**STAFF RECOMMENDATION**  
**3925 Cambridge Avenue**  
**November 19, 2018**

**Application:** New Construction—Addition; Setback Determination  
**District:** Cherokee Park Neighborhood Conservation Zoning Overlay  
**Council District:** 24  
**Map and Parcel Number:** 10308023200  
**Applicant:** Van Pond, Architect  
**Project Lead:** Sean Alexander, sean.alexander@nashville.gov

**Description of Project:** A proposed side and rear addition to an historic house. The addition will be one story and will include a front-facing garage. A rear setback determination is requested, reducing the setback from twenty feet (20') to five feet (5').

Figure 1: Demolition plan

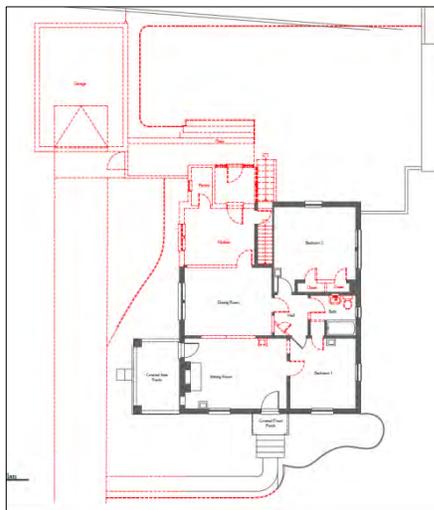
**Demolition:** The proposed addition would “wrap” the rear-left corner of the house, and involves demolishing portions of the house at the rear and left side of the original building. In general additions are most appropriate at the rear or in certain situations they may be appropriate on the side, but wrapping a corner is generally not appropriate because doing so requires more demolition of the original building and makes the addition less reversible.

Staff finds that the circumstances of this lot, however, could justify an addition wrapping the corner. Because the lot is eighty feet (80') wide and only one hundred, five feet (105') deep, the buildable area is more to the side than the rear, unlike the typical situation for most houses. Because of the atypical lot dimensions at 3925 Cambridge Avenue, Staff finds that this partial demolition at the corner would meet section III.B.2 of the guidelines for appropriate demolition,

In order to preserve an indication of the original form when an addition wraps a corner, the addition should tie into the structure's walls allowing the eave and roofline to remain.

① Proposed Main Floor Plan

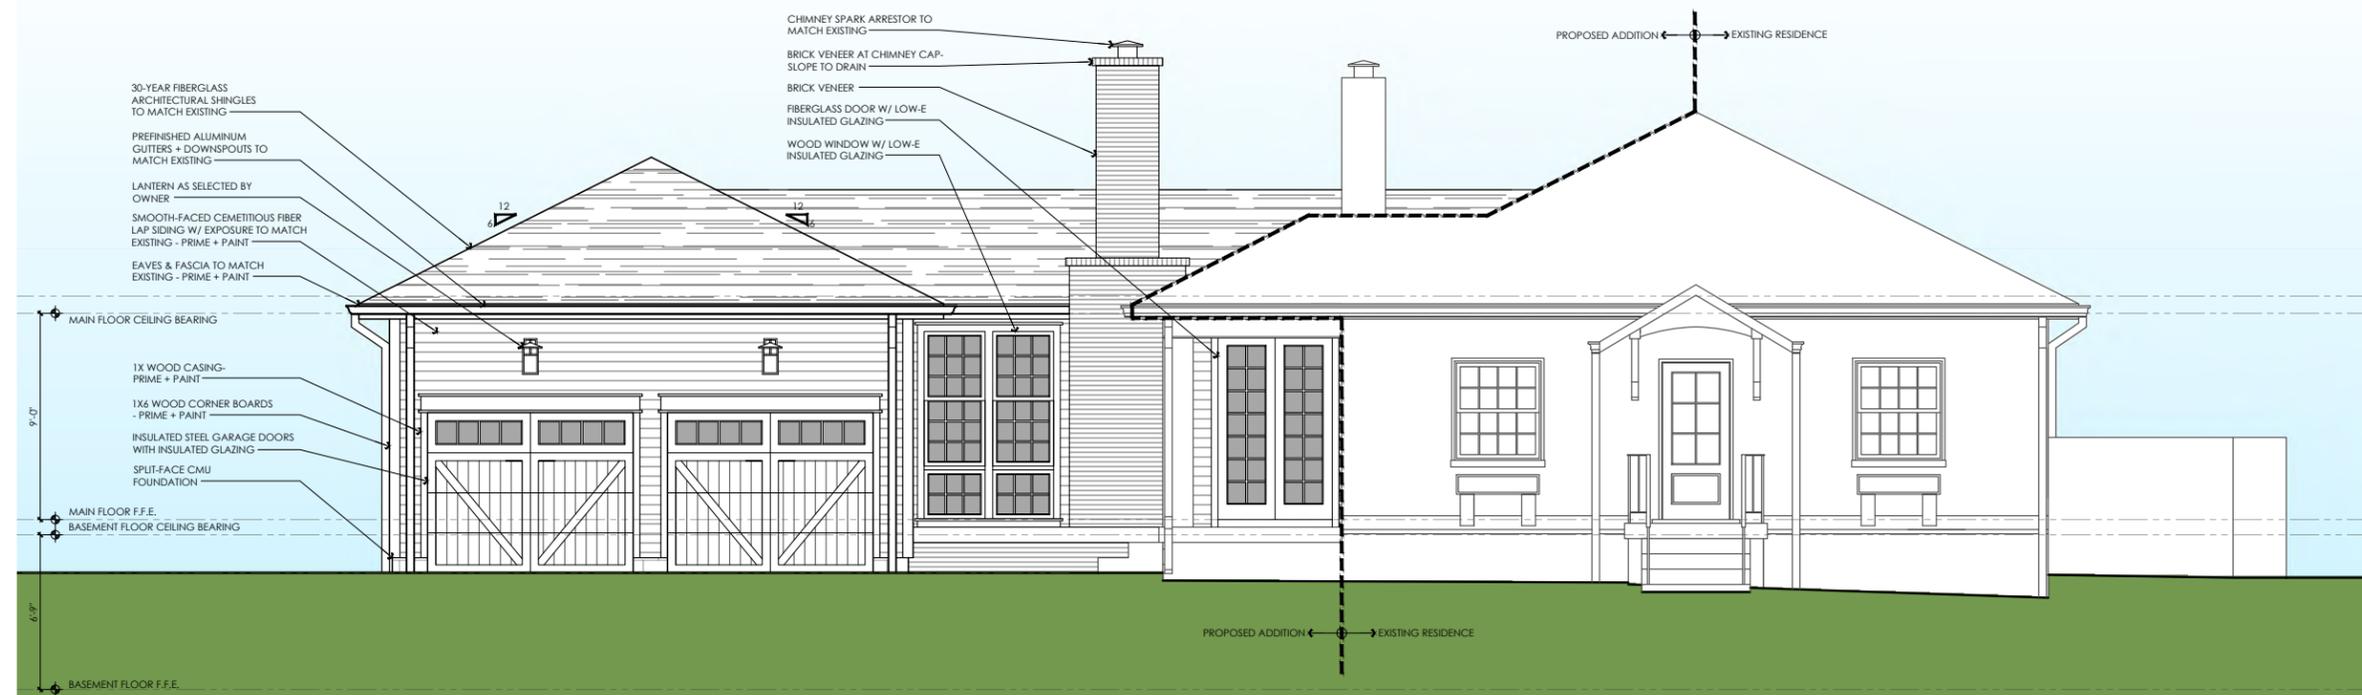
**Location & Removability:** The proposed addition will attach to the historic house at the midpoint of the rear-wall and on the left side twenty-five feet (25') back from the front, wrapping the rear-left corner but leaving the front two-thirds of the left wall unaltered. The front and right side will not be impacted by the addition.

While a corner attachment may be appropriate at 3925 Cambridge Avenue, Staff finds that the form of the proposed addition is not subordinate to the historic house. This is discussed further and in greater detail in the analysis for "Height & Scale" and "Setback & Rhythm of Spacing."

The hyphen component of the addition will attach to the left side of the house twenty-five feet (25') back from the front and will be nineteen feet (19') wide, extending eleven feet (11') past the house's eight foot (8') deep side porch. The garage component will extend another twenty-three feet (23') wide, stepping forward thirteen feet (13') from the hyphen up to twelve feet (12') behind the front edge of the house. The width of the addition, thirty-four feet (34') wide from the edge of the porch will be nearly equal to that of the thirty-nine foot (39') wide historic house. The left side of the garage component will be forty-nine feet (49') deep, thirteen feet (13') deeper than the historic house.

When appropriate, side additions are typically approved to add up to half the width of an historic house and are typically required to be kept at or behind the house's midpoint. While the dimensions on this lot may justify an addition being wider, Staff finds that the effect of the width and forward location combined make the addition not compatible and subordinate to the historic building.

Staff finds that while the height of the addition is appropriate, the scale of the addition overall is not subordinate to the house and that the proposal does not meet section II.B.1.b of the design guidelines.

Setback & Rhythm of Spacing: The lot is one hundred, five feet (105') deep on the right and one hundred, eleven feet (111') on the left and the house is located only thirty-two feet (32') from the rear property line. With a standard rear setback requirement of twenty feet (20'), the buildable area behind the house would be limited to approximately twelve feet (12') deep.

The applicant is proposing an addition that would extend the depth of the house by twenty-eight feet (28') coming to five feet (5') of the rear property line. The Commission has the authority to determine setbacks when doing so is appropriate for the historic context, and given the size of the lot, Staff finds that the reduction of the rear setback may be appropriate. In the past, the Commission has reduced the rear setback to ten feet (10') and even less if the property backed up to a railroad or high-density development. In this case, the property backs up to the rear of two properties that are zoned the same, have developed in the same manner, and are located in the Cherokee Park Neighborhood Conservation Zoning Overlay. The lots behind are also less than the typical depth of one-hundred and fifty square feet (150') and have minimal opportunity for rear additions. If 3925 Cambridge is allowed a five foot (5') rear setback then it would stand to reason that 4020 and 4018 Aberdeen could request the same. The result could be a large stretch of area with just ten feet (10') between the rear walls of buildings in a situation where they would typically have at least forty feet (40'). Staff does not recommend a reduced rear setback beyond ten feet (10')

The standard width for lots on Cambridge Avenue is sixty feet (60'), although this lot and a few others are wider. Because the buildable area of the rear yard is limited, staff finds that the side yard may be an appropriate location for an addition or garage. However, Staff finds that the massing of an addition sitting only twelve feet (12') back from the front of the house is not subordinate to the historic form and is not compatible with the rhythm of the street, especially on an addition on which the dominant feature is a street-facing garage.

Staff finds that the proposed addition does not meet section II.B.1.c of the design guidelines.

*An option that would be more appropriate might include having the garage portion of the addition sitting further back at the mid-point of the side of the house, keep a ten foot (10') rear setback, maintaining the full original roof form of the historic building because the walls will be fully demolished, and recessing the garage doors themselves by at least one foot (1') and adding a hood or awning above the garage doors to lessen the impact of a front-loading garage. A recommendation with conditions was not given since these options would require a redesign.*

Proposed Front Elevation  
1

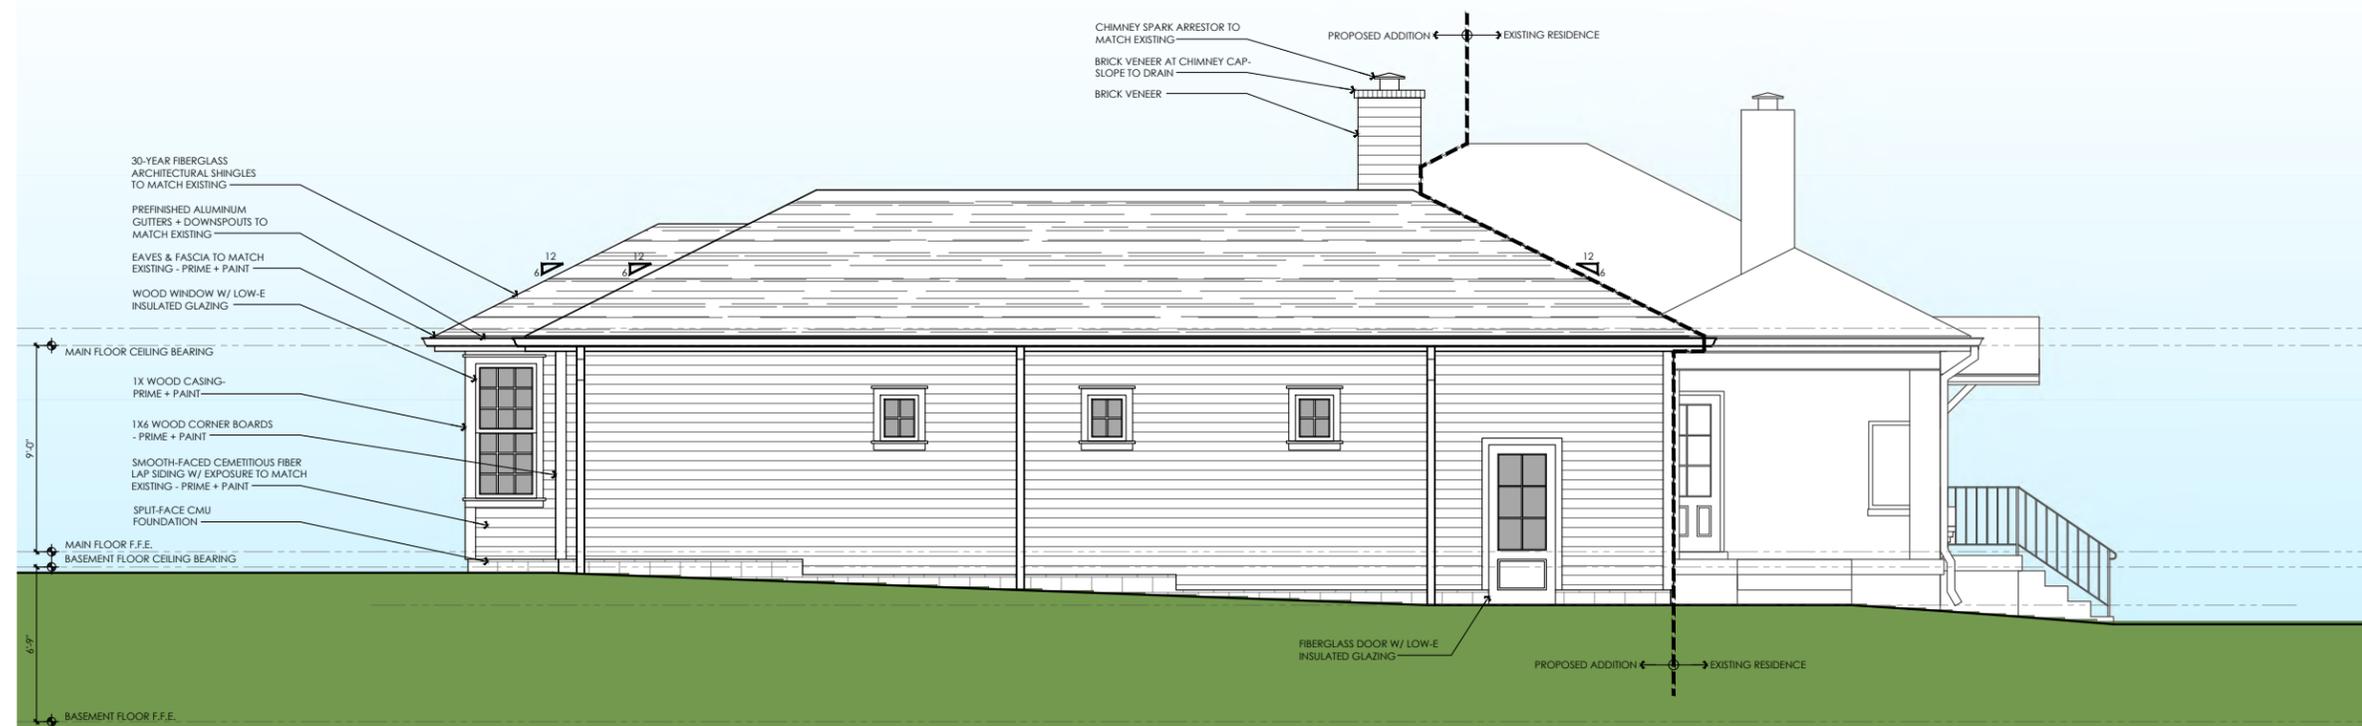
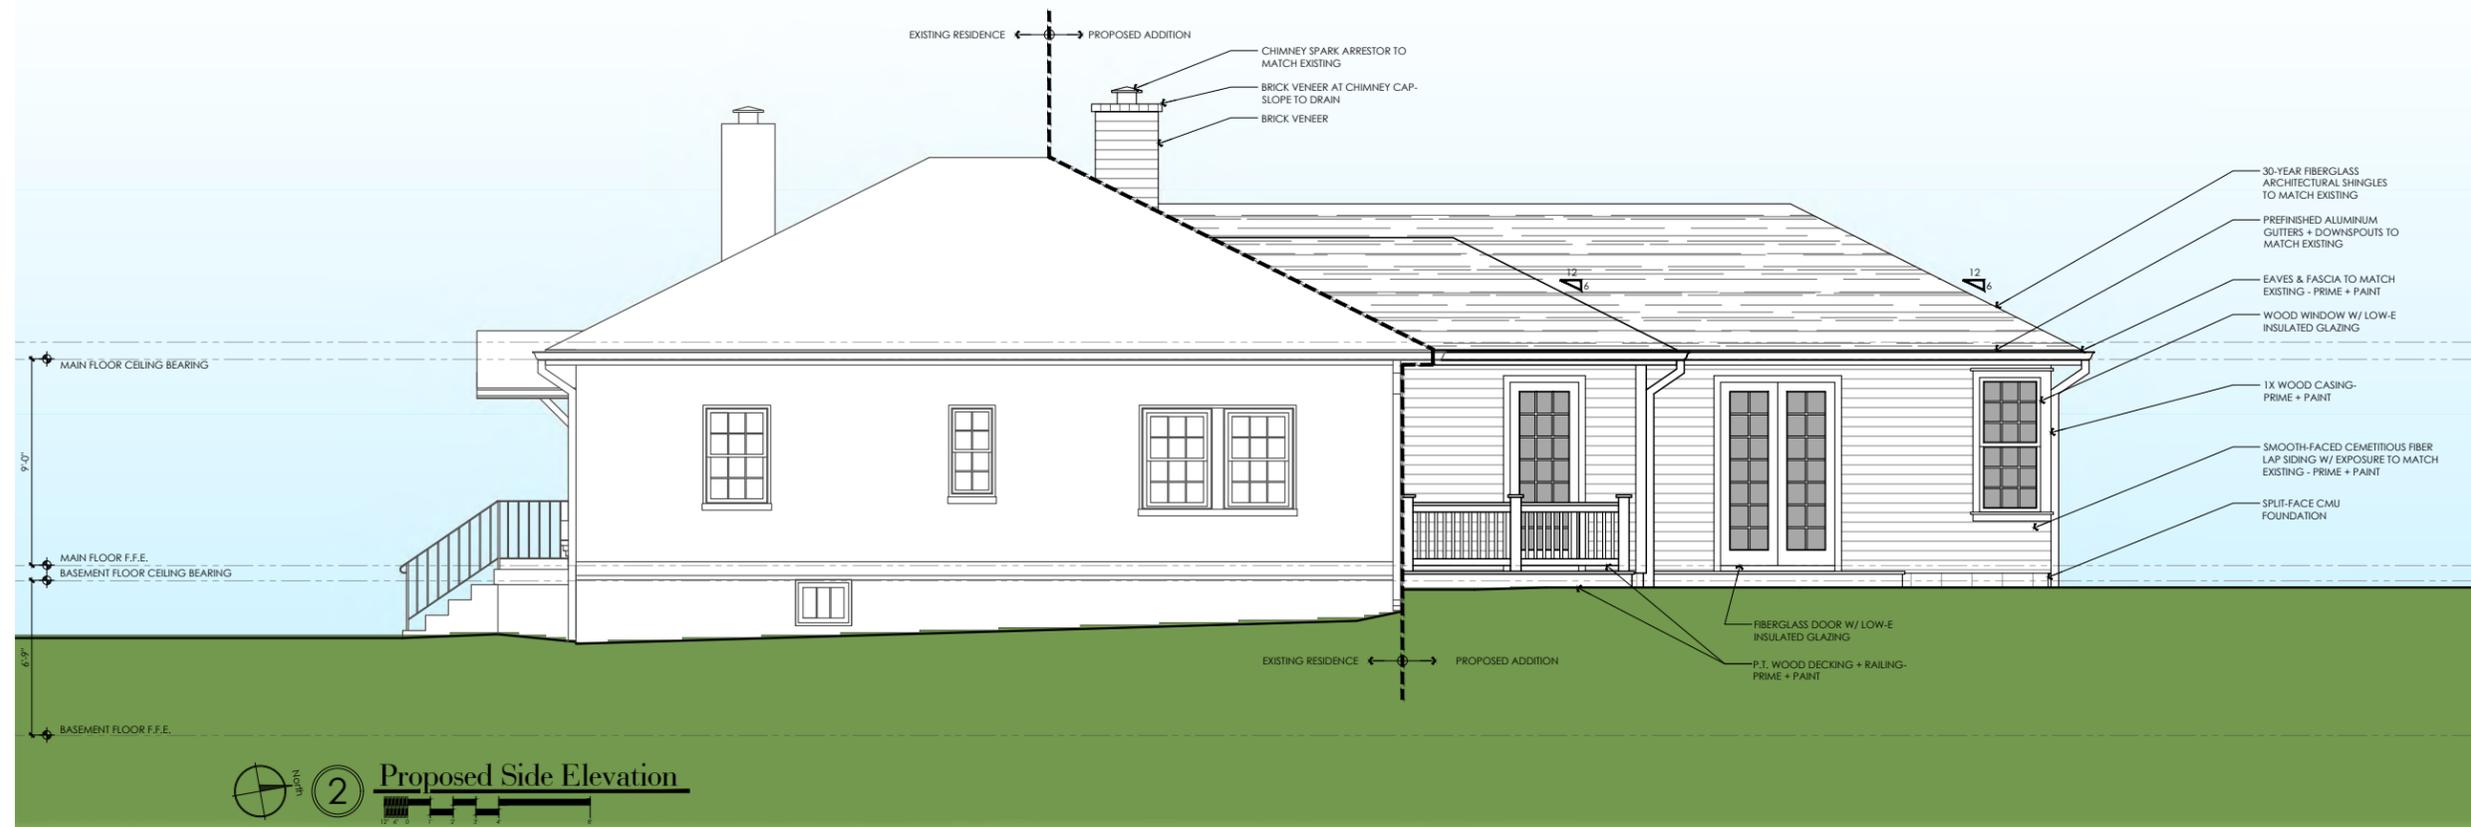
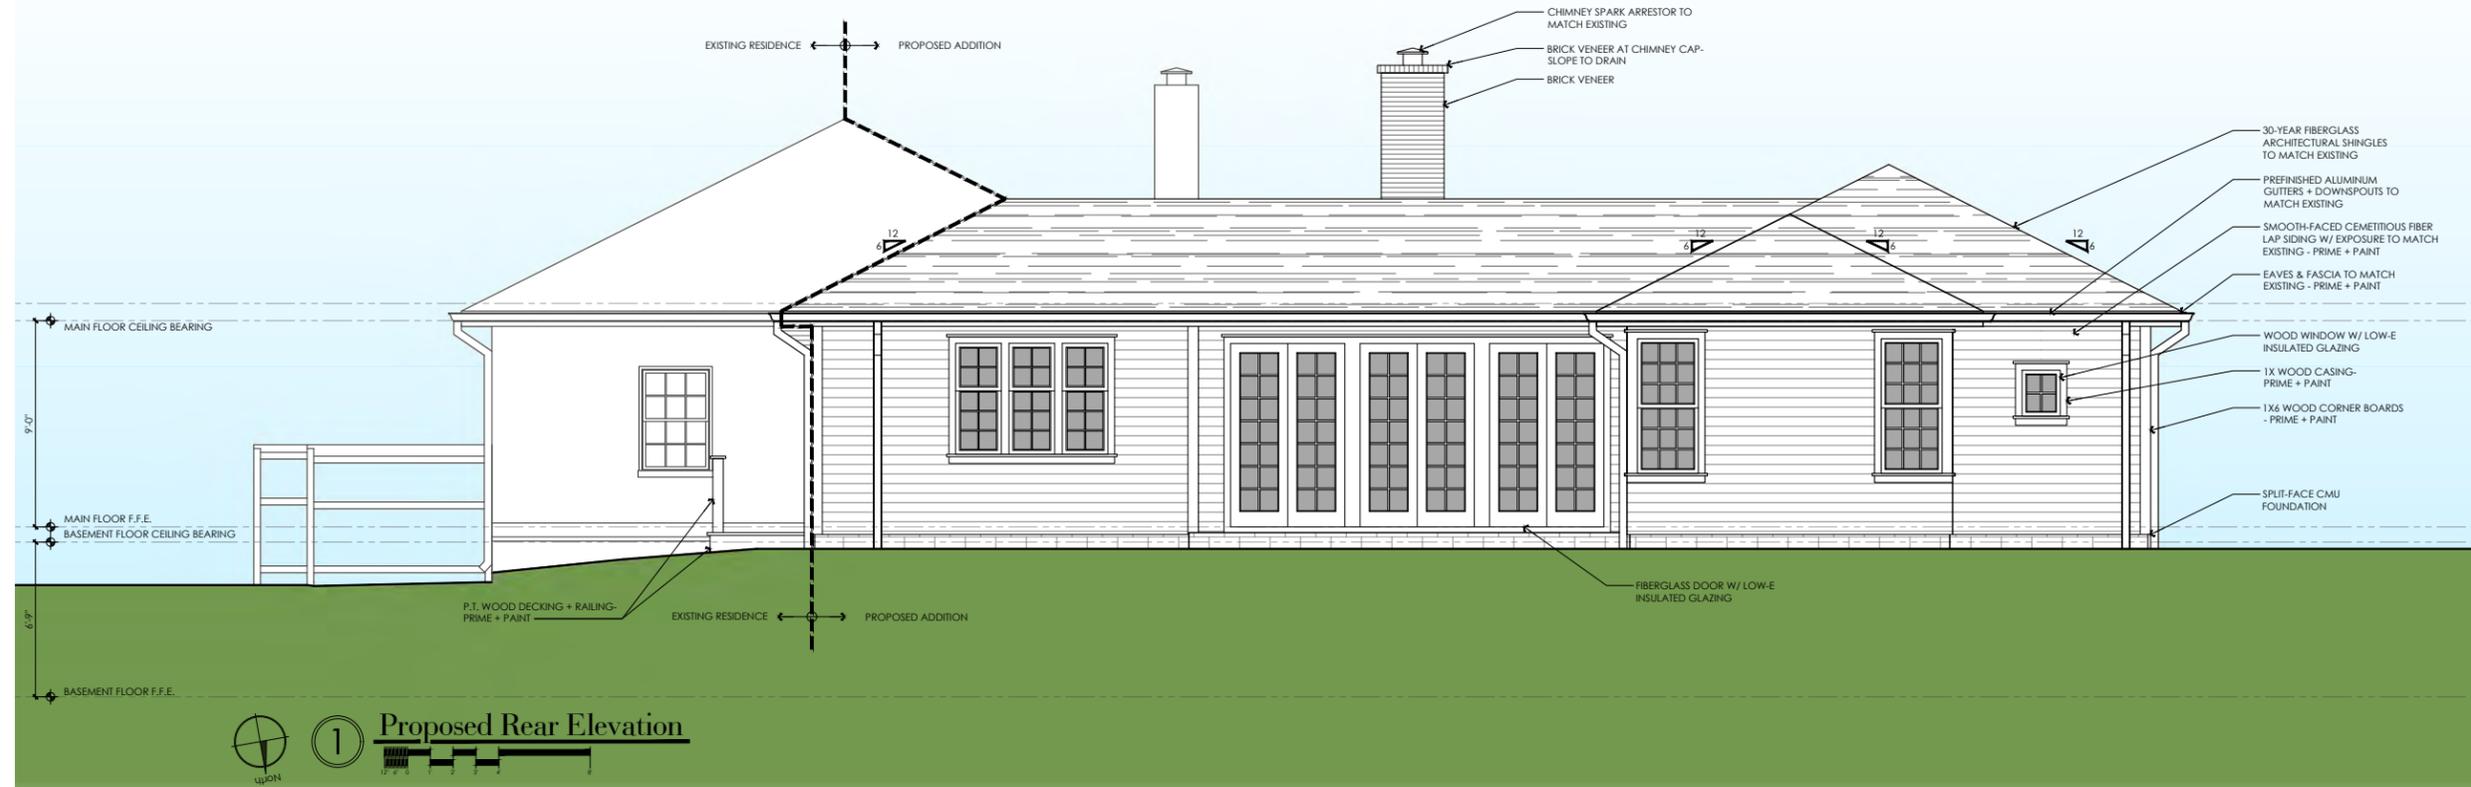
Height & Scale: The addition will have two components, both one story tall. The primary component will consist of a garage and master suite, connected to the historic house by a component containing a "great room." The garage/master component will have a hipped roof with a ridge peak two feet (2') lower than the peak of the historic house's roof. The great room component will act as hyphen with the roof tying in one foot, six inches (1'-6") below the ridge of the garage and three feet (3') lower than that of the house. The eaves of both components will align with the eaves of the historic house.

Roof form: The roof of the addition will be hipped on the garage components with a 6:12 pitch, and a matching pitch on the hyphen. These roof forms and pitches match the hipped roof of the historic house. Staff finds that the roof forms of the addition are compatible with the historic house and the project would meet section II.B.1.e of the design guidelines.

Proportion and Rhythm of Openings: The windows on the proposed addition are vertically oriented and with the exception of three square windows on the left side of the garage are generally twice as tall as they are wide, or taller. These proportions are compatible with the proportions of openings on the historic house. There are no large expanses of wall space without a window or door opening. Staff finds the project's proportion and rhythm of openings to meet section II.B.1.g of the design guidelines.
